**Lower Hill Redevelopment**  
First Amendment to Preliminary Land Development Plan

# Amendment to Section 1: Introduction & Section 2: Regulating Plans

Figure 2.66 Parking and Service Regulating Plan

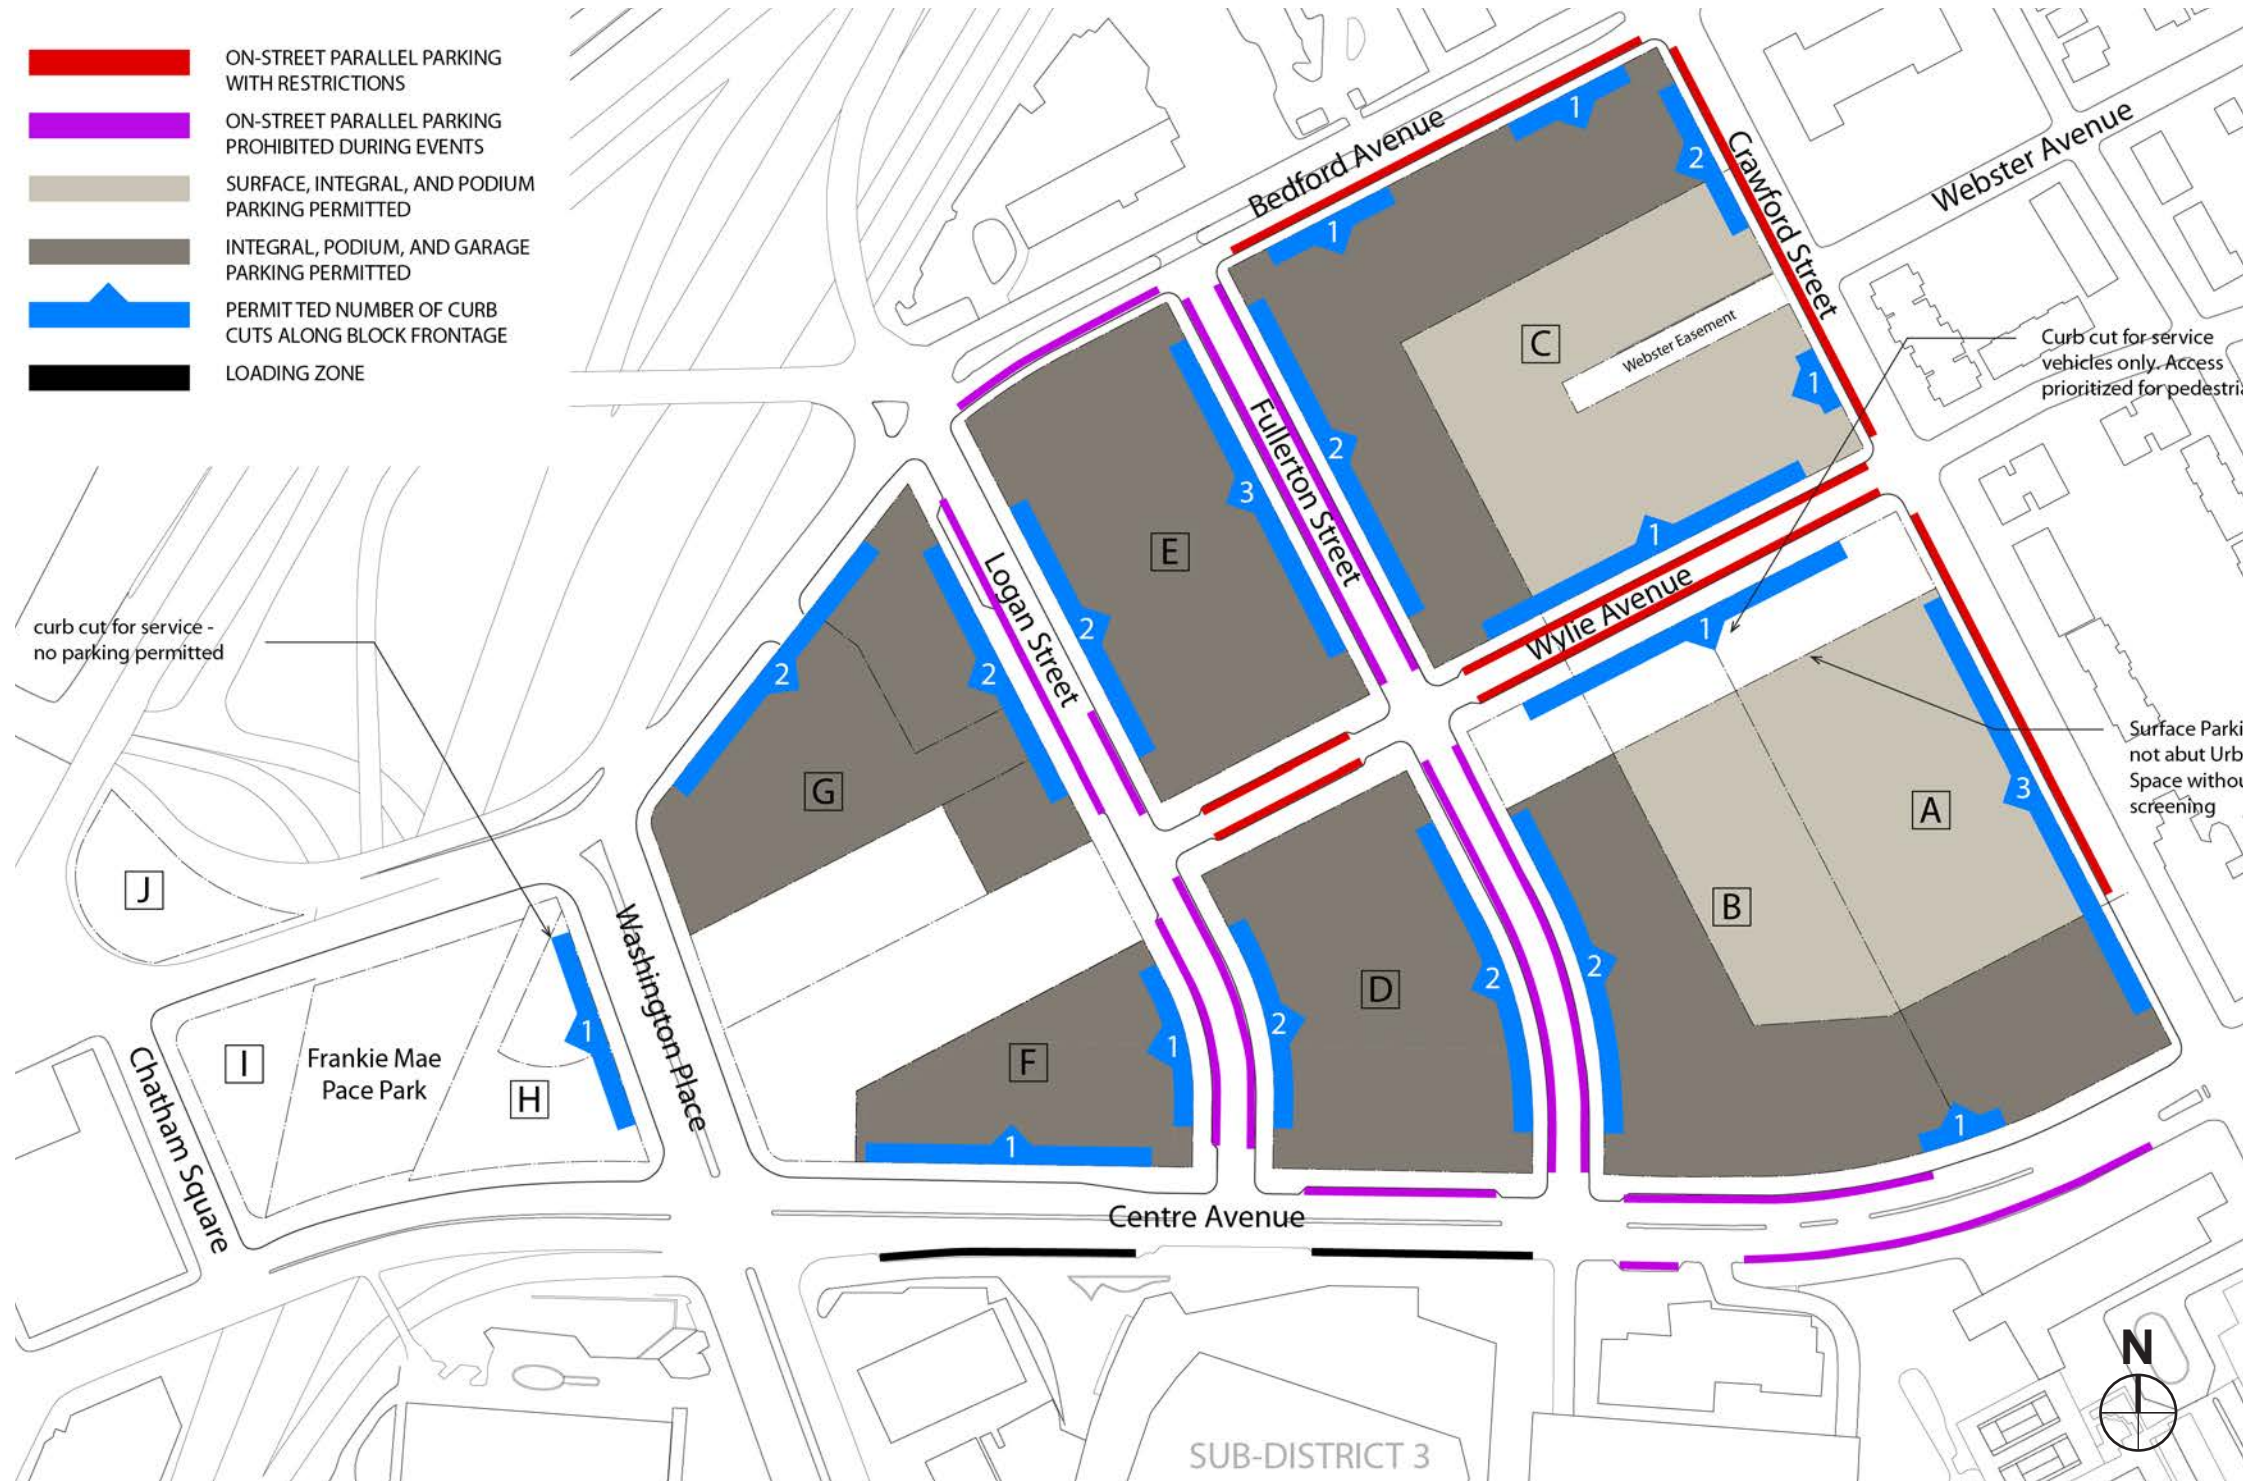
Figure 2.66 is revised to reflect the Block revisions identified in Section 2.4 and as follows: (1) one curb cut between Block A1 and B1 is permissible along Centre Avenue, (2) one curb cut on Block A1 is permissible along Centre Avenue, (3) one curb cut on Block B1 is permissible along Centre Avenue (4) Three curb cuts on Block E are permissible along Fullerton Street, (3) two curb cuts on Block F are permissible along Centre Avenue. (4) one curb cut on Block H-R is permissible along Washington Place for building services.

Figure 7.3 Enlarged illustrative plan showing a small adjacent pavilion /restaurant with an outdoor dining terrace, pylon marking the entry plaza, and a tree-lined promenade.

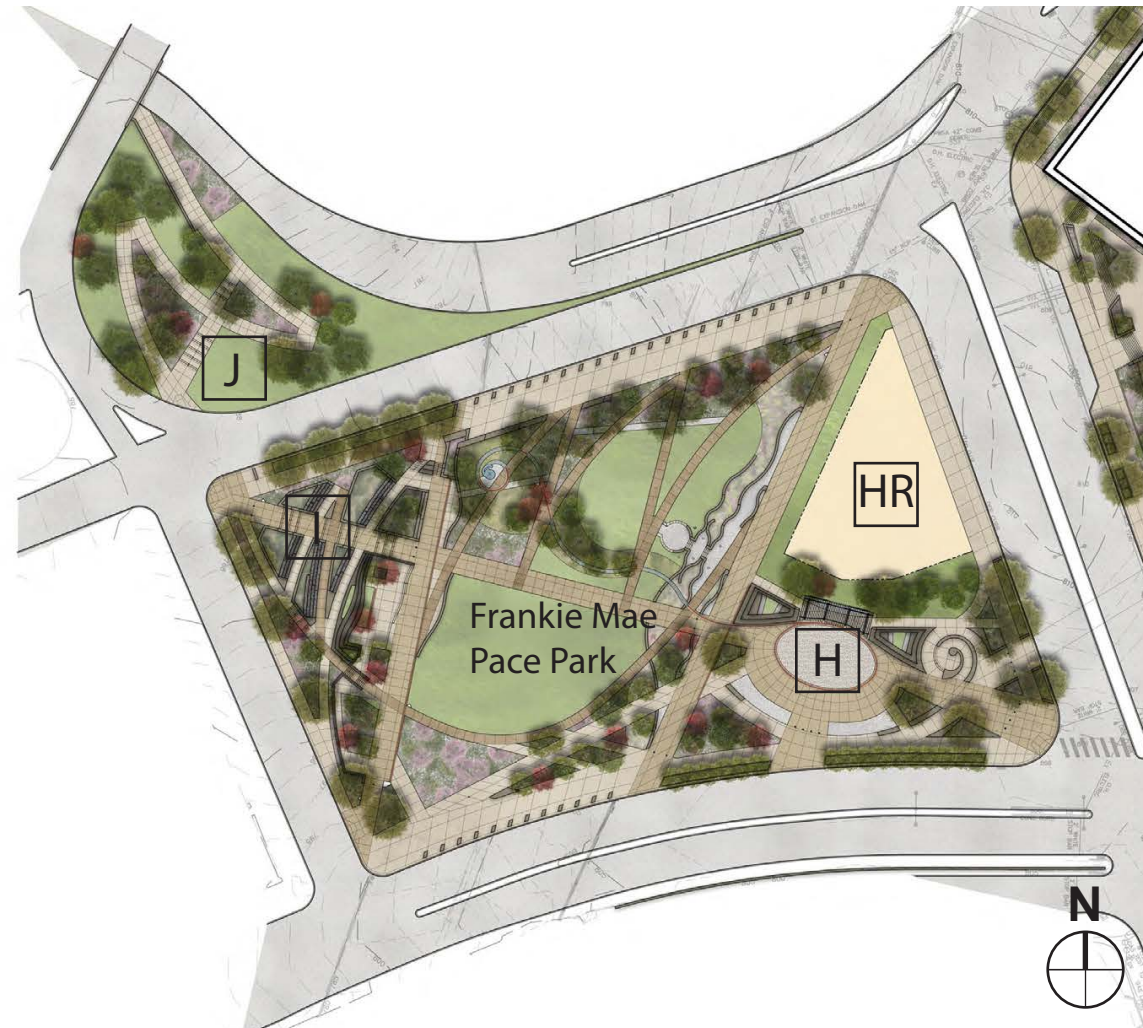
Figure 7.2 is revised to reflect the Block revisions identified in Section 2.4. and as follows: (1) Block A Urban Open Space is revised to identify Block A2 and B2 Urban Open Spaces, (2) Block F is revised to reflect the configuration of F2 Urban Open Space and F1 development parcel, (3) Block G4 Urban Open Space is added to conform to the approved FLDP, (4) Block H Urban Open Space is revised to reflect the completed Frankie Mae Pace Park.

Figures 7.3, 7.4, 7.9, and 7.16 are revised accordingly.

Figure 7.23 Plan showing potential locations of art installations.

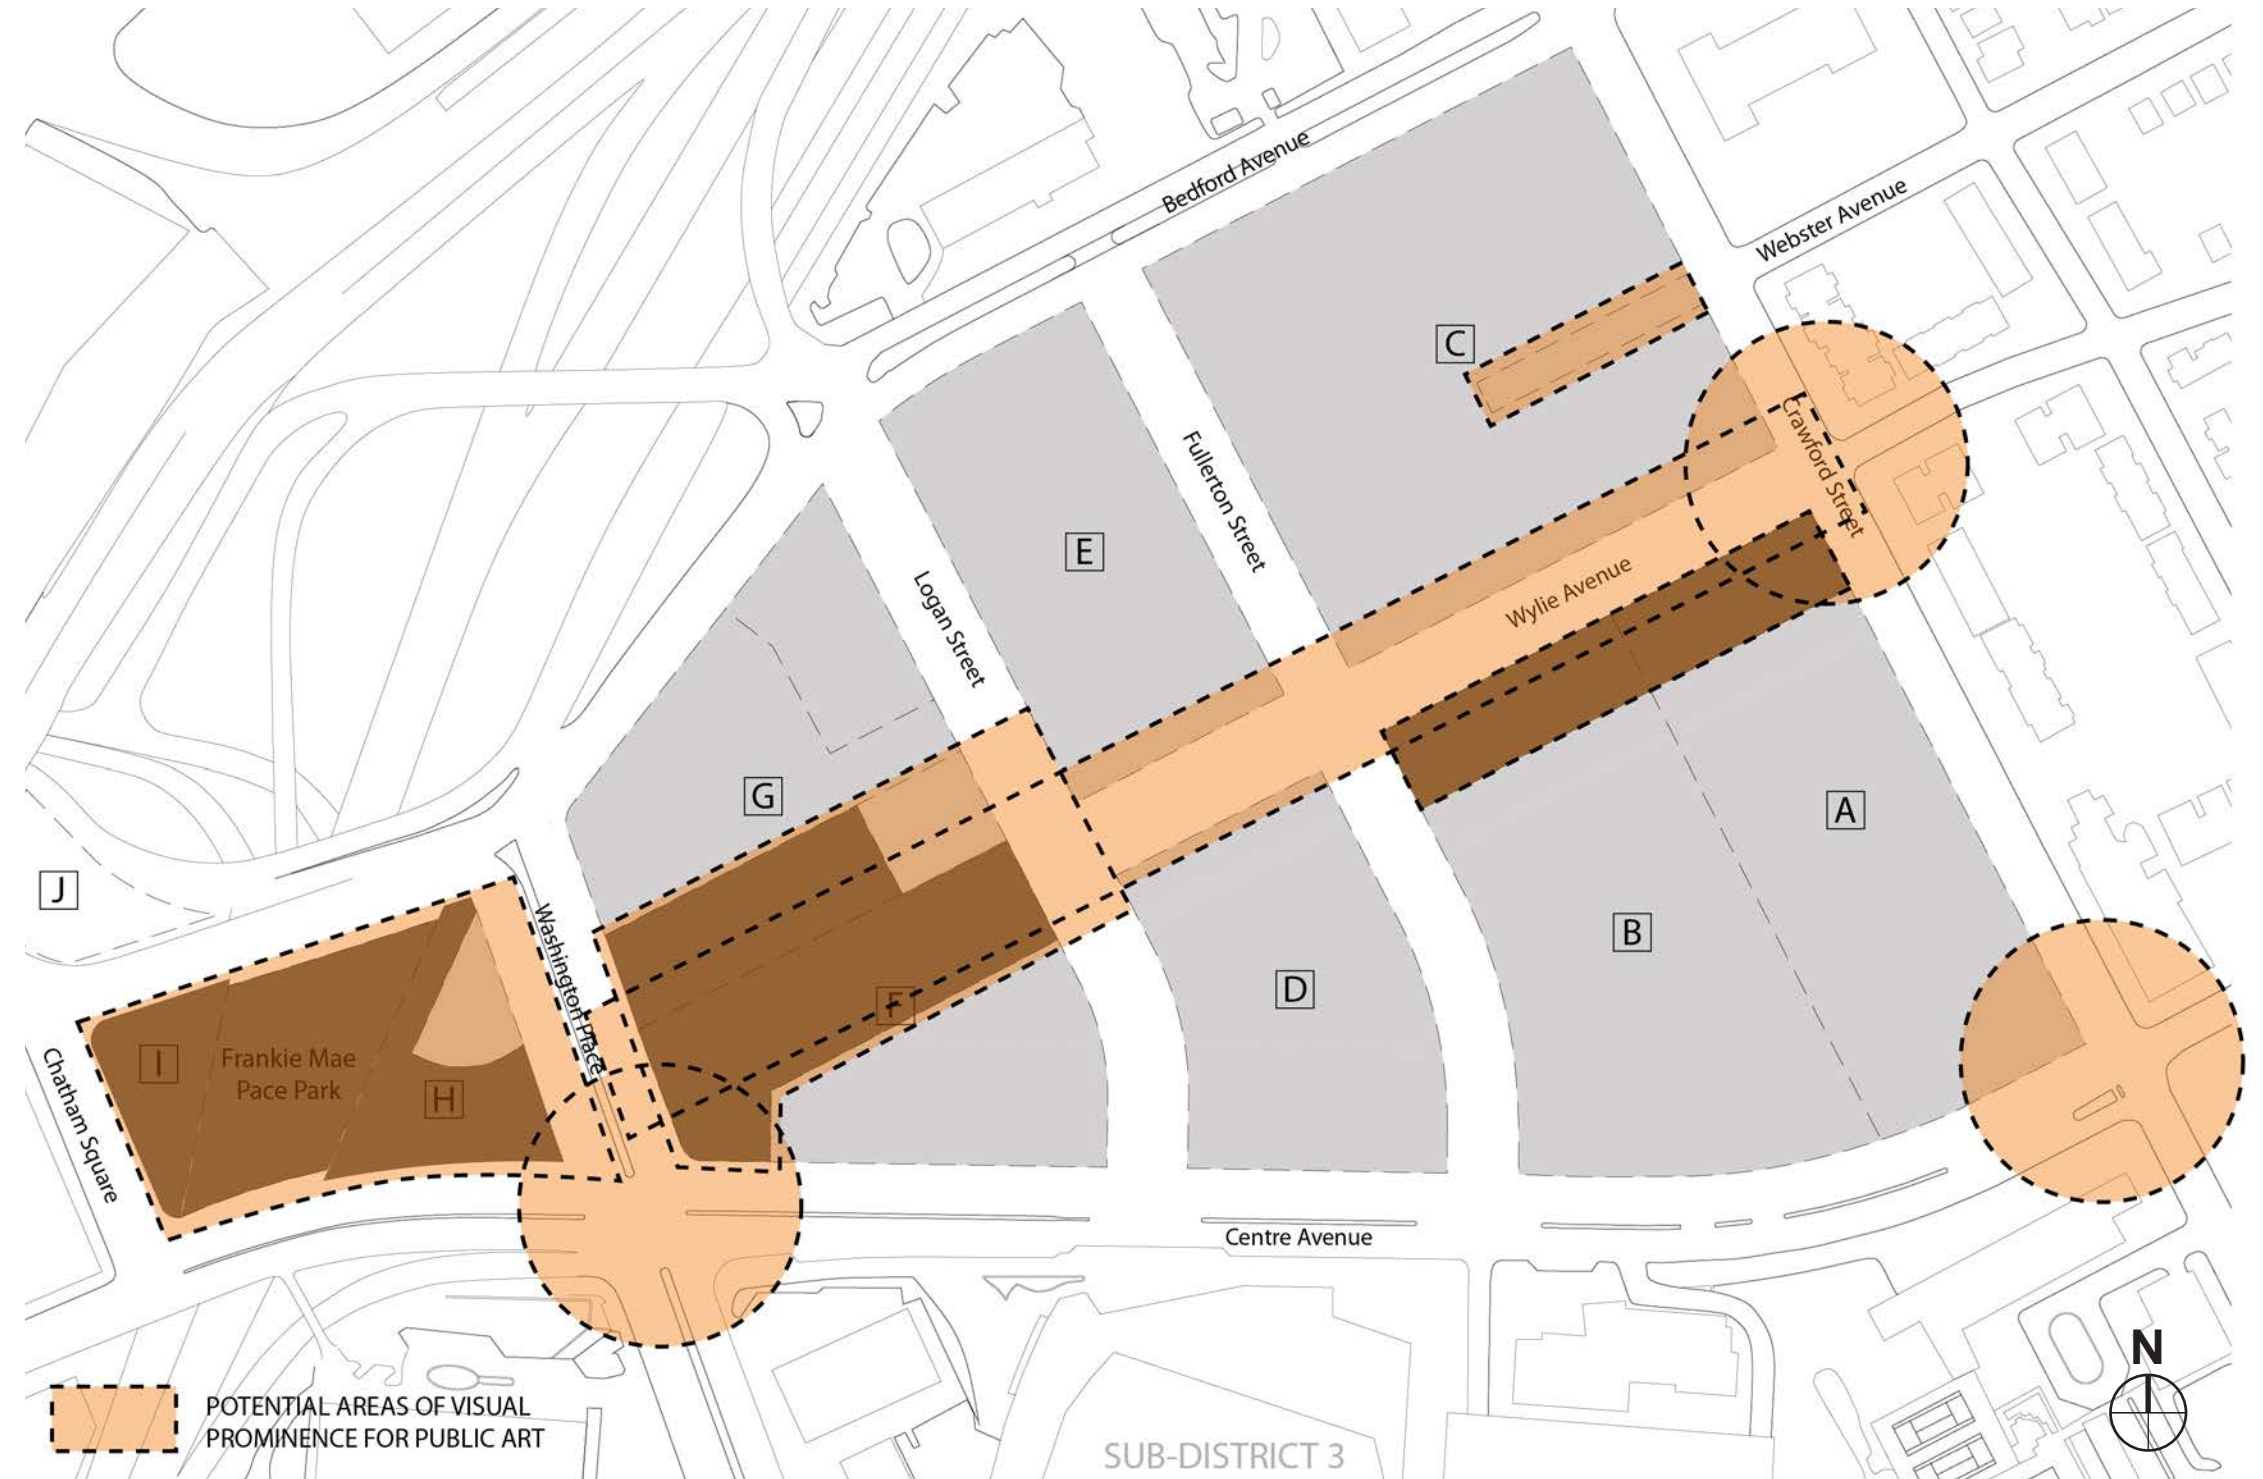
Figure 7.23 is revised to reflect the Block and Urban Open Space revisions identified in Section 7.2.
